RECEIVE AND FILE COMMUNICATION FROM THE PLAN AND ZONING COMMISSION
REGARDING PRELIMINARY PLAT "THE CREEK AT ECHO VALLEY PLAT 2" FOR 9.14 ACRES OF
PROPERTY IN THE VICINITY OF 8050 GOLF HOUSE DRIVE, TO ALLOW THE PROPERTY TO BE
SUBDIVIDED INTO FIFTEEN (15) BUILDABLE LOTS AND THREE (3) OUTLOTS

(PLAT-2025-000023)

STAFF REPORT TO THE PLANNING COMMISSION

C2.0
2407.601

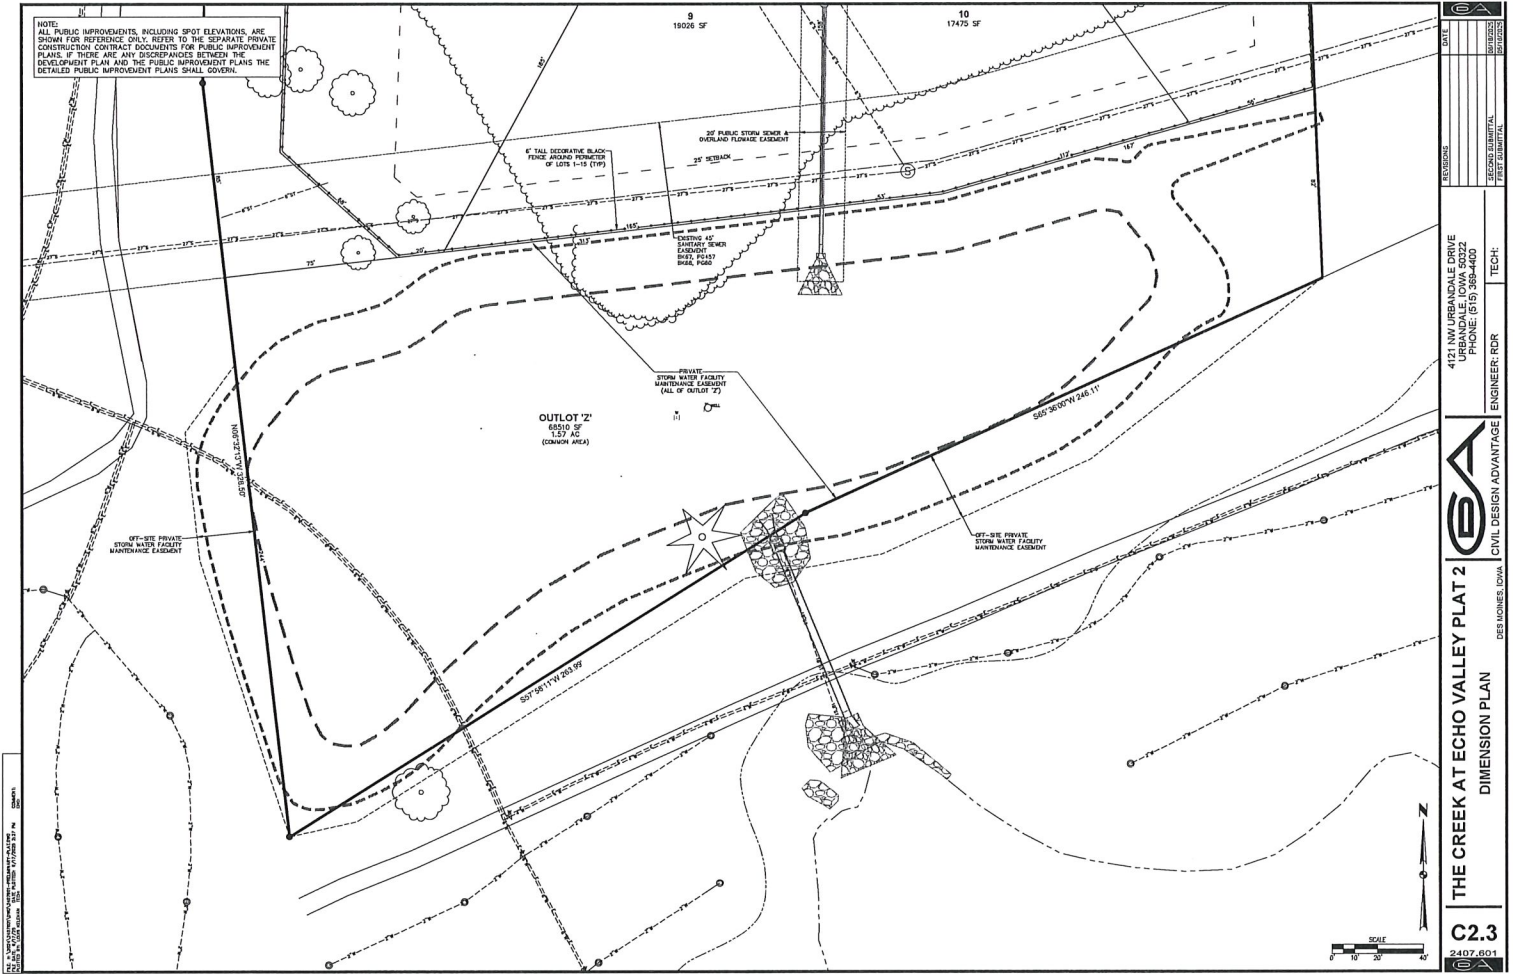
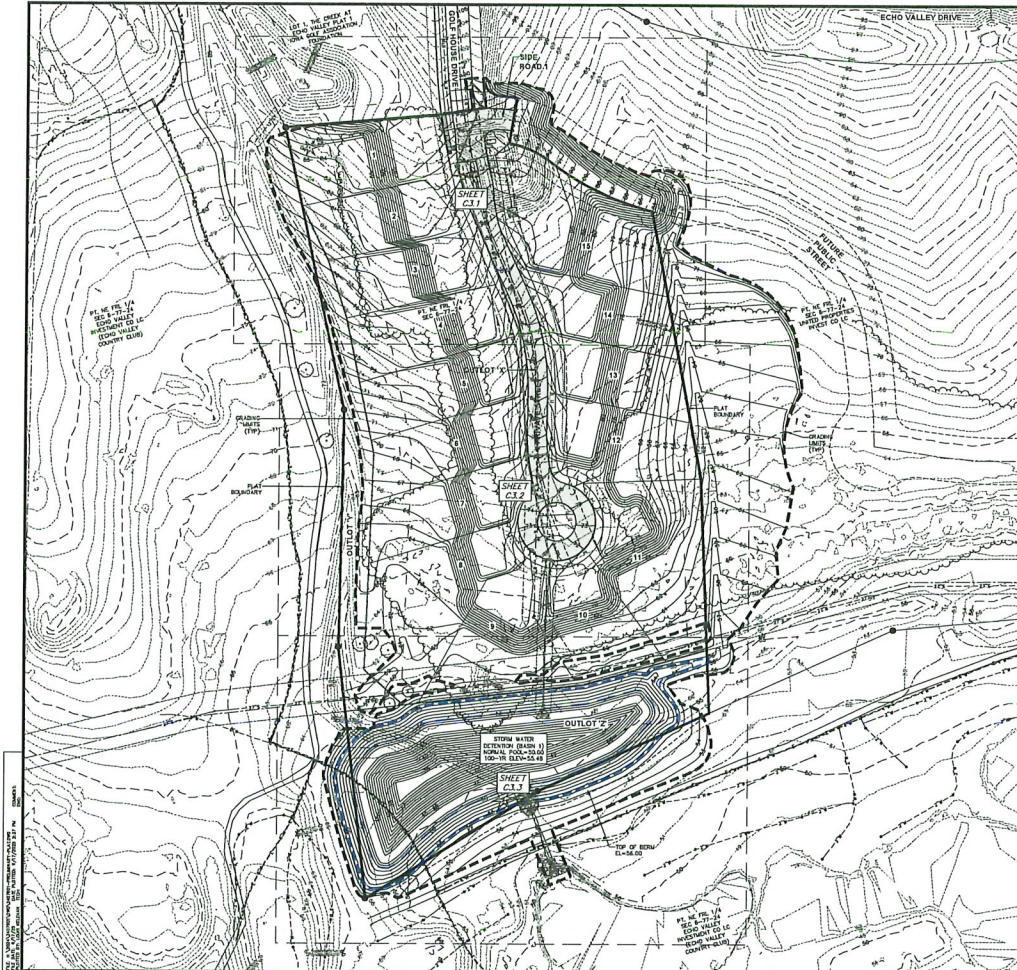
- 2. Sidewalk:** Currently, there are no sidewalks included in the plat. With future residential development planned to the east, Development Services is requesting the inclusion of sidewalks throughout the platted area to ensure a well-rounded and cohesive development that is accessible for both vehicle user and pedestrians. The portion of Echo Valley Drive directly to the north of the plat is listed as a Priority 2 sidewalk gap in the Move DSM: Transportation Master Plan.

- 3. Fire Access:** Fire Code lists the maximum length of a dead-end street as 750 feet. As currently shown, the distance from Echo Valley Drive to the south end of the private street, Outlot 'X', is approximately 900 feet. This excessive distance can be mitigated in two ways. The first option is to include sprinklers within each of the structures to be built. The second option is to provide a secondary fire access, likely an access road that is separate from Golf House Drive to connect Outlot 'X' with Echo Valley Drive.

1. Inclusion of sidewalks throughout the development.

2. Compliance with all fire code requirements.
3. Compliance with all administrative review comments.
